## CDM: Recommendation Form for Small Scale Methodologies (version 01)

Date of SSC WG meeting:	As per procedures for fast track clarifications
Title/Subject (give a small title or specify the subject of your submission, maximum 200 characters):	Clarification regarding two measures taken in the plant simultaneously - Fuel switch and energy efficiency
Indicative methodology to which your submission relates (refer the items of Appendix B of the Simplified Modalities and Procedures), if applicable.	AMS-III.B: Switching fossil fuels AMS II.D: Energy Efficiency and fuel switching measures for industrial facilities
Name of the authors of the query:	Siddharth Yadav Institution: SGS United Kingdom Ltd <a href="mailto:Sanjeev.kumar@sgs.com">Sanjeev.kumar@sgs.com</a> <a href="mailto:Siddharth.yadav@sgs.com">Siddharth.yadav@sgs.com</a>

SSC-Submission number	SSC_162
Date when the form was received at UNFCCC secretariat	28 March 2008
Date of transmission to the EB	28 March 2008
Date of posting in the UNFCCC CDM web site	28 March 2008

Figure 1: Baseline

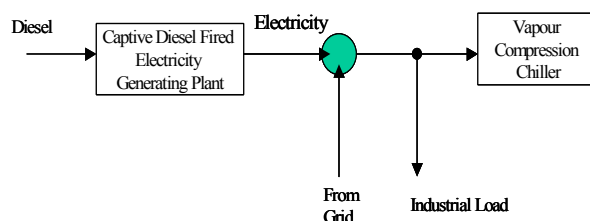
The project activity as described in the PDD involves the installation of a new gas based captive electricity generation unit and a vapor absorption chiller (see figure 1 and 2 below). The electricity and the waste heat produced by the gas turbine electricity generating unit will displace:

- Part A: on-site captive diesel fired electricity generation unit and grid electricity import, and
- Part B: a portion of electricity used in the vapor compression chiller.

The DOE seeks clarification whether the combination of AMS III.B (for fuel switch activity) and AMS II.D (for energy efficiency activity) can be applied for the proposed project activity.

The SSC WG agreed to clarify that the application of AMS III.B and AMS II.D to the proposed project activity is not appropriate. The reasons are elaborated below.

As regards Part A of the submission, it is understood from the description that the project activity is the installation of a new gas based energy generation system that will substitute diesel generation (component A) as well as import of grid electricity (component B). The SSC WG agreed to clarify that approved methodology AMS III.B is not applicable to the component B of the proposed project activity, i.e. displacement of grid electricity. Consideration of baseline emissions from the grid electricity use and combined margin approach to calculate grid emission factor are not covered under AMS III.B. However, component A of the proposed project activity, i.e. natural gas based energy generation substituting diesel electricity generation, is an eligible activity under the AMS III.B if all the other conditions of the methodology are met. *(In this context the SSC WG noted that the PDD mentions the capacity of the gas based power plant as 1.4 MW but does not mention the capacity of the diesel generator set in the baseline. The PDD also states electricity needs in the baseline are met by diesel generation and in the case of ‘emergency’ grid electricity is used. Elsewhere in the PDD it is stated western grid is not reliable therefore PP resorted to diesel generation in the baseline which is not coherent with the explanation of use of grid electricity as an emergency source).*

As regards Part B of the submission, the project activity proposes to apply AMS II.D for the component involving shift from compression refrigeration system to absorption refrigeration system to meet the cooling load demands. This is not appropriate for several reasons:

- AMS II.D covers project activities aimed primarily at energy efficiency for example replacing an existing electrical motor with a more efficient electrical motor. Shift to vapor absorption system chiller from vapor compression system chiller in itself will not constitute an energy efficiency activity, when viewed in isolation, in fact the COP of vapor compression system is usually higher, a value of 5 is technically feasible. However under specific situations, for example when using a electricity focused combined heat and power plant (CHP)<sup>1</sup> using the waste heat in the engine exhaust gas in the absorption system might lead to favorable conditions in terms of technical efficiency.

- Shift to vapor absorption system (using either Li-Br water or Ammonia-water refrigerant/absorbent combination) from the vapor compression chiller which usually uses a CFC or HCFC refrigerant would result in a need to account for the direct emissions of the baseline refrigerant (possible routes include destruction, recovery/recycling or release to atmosphere). These issues are not covered in AMS II.D.

Further the PDD shows increased electricity generation in the project activity compared to the baseline level and similarly an increased installed cooling capacity as compared to the baseline capacity. In this regard the author of the submission may wish to note the guidance from the Board, i.e. Paragraph 10 of annex 1 of EB 08 that states “If a proposed CDM project activity seeks to retrofit or otherwise modify an existing facility, the baseline may refer to the characteristics (i.e., emissions) of the existing facility only to the extent that the project activity does not increase the output or lifetime of the existing facility. For any increase of output or lifetime of the facility which is due to the project activity, a different baseline shall apply”.
